Access Compliance Report

Public Rights-of-Way

Intersection ID: 11685	Main Street: E_19TH_ST	Cross Street: SEIGLE_AV	Location:	N
ADA ID: 7DB45CF58A7D	Ramp Type: Perp	Initial Pass/Fail: Fail	Overall Compliance: No	Severity Score: 10

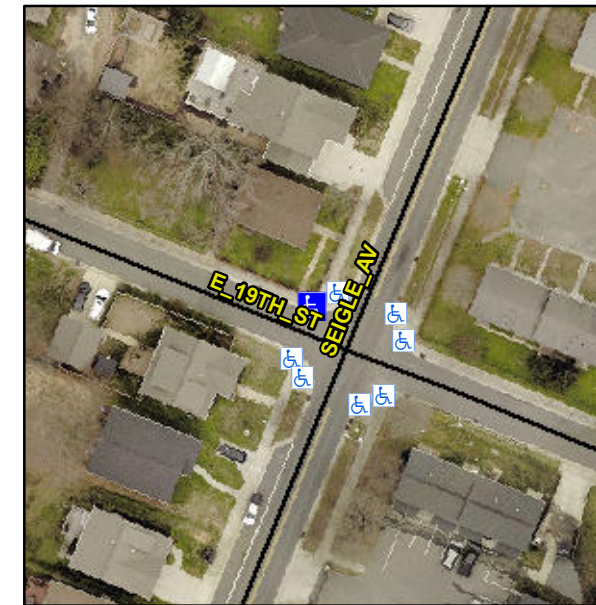
R304.5.1, R304.5.3

Compliance	Description	Data	Compliance	Description	Data
N/A	Ramp Length (in)	60.0	Yes	Ramp Slope (%)	6.1
No	Ramp Width (in)	47.5	No	Ramp XSlope (%)	4.7
N/A	Flare Type LT	N/A	N/A	Flare Type RT	N/A
N/A	Flare Slope LT (%)	N/A	N/A	Flare Slope RT (%)	N/A
N/A	Flare Traversable LT?	N/A	N/A	Flare Traversable RT?	N/A
N/A	Landing Length (in)	N/A	N/A	DWS Provided?	N/A
N/A	Landing Width (in)	N/A	N/A	DWS Contrast?	N/A
N/A	Landing Slope (%)	N/A	N/A	DWS Length (in)	N/A
N/A	Landing X Slope (%)	N/A	N/A	DWS Full Width?	N/A
N/A	Landing Curb? (Y/N)	N/A	N/A	DWS Offset (in)	N/A
N/A	Shared Landing?	N/A			
N/A	Gutter Ponding?	N/A	N/A	Gutter Slope (%)	N/A
N/A	Gutter Lip Ht (in)	N/A	N/A	Gutter X Slope (%)	N/A
N/A	Painted X Walk1?	No	N/A	Painted X Walk2?	N/A
	X Walk 1 Direction	To SW		X Walk 2 Direction	N/A
N/A	X Walk 1 Width (in)	N/A	N/A	X Walk 2 Width (in)	N/A
	X Walk 1 Slope (%)	4.5		X Walk 2 Slope (%)	N/A
	X Walk 1 X Slope (%)	7.1		X Walk 2 X Slope (%)	N/A

Remove & Replace Entire Ramp.
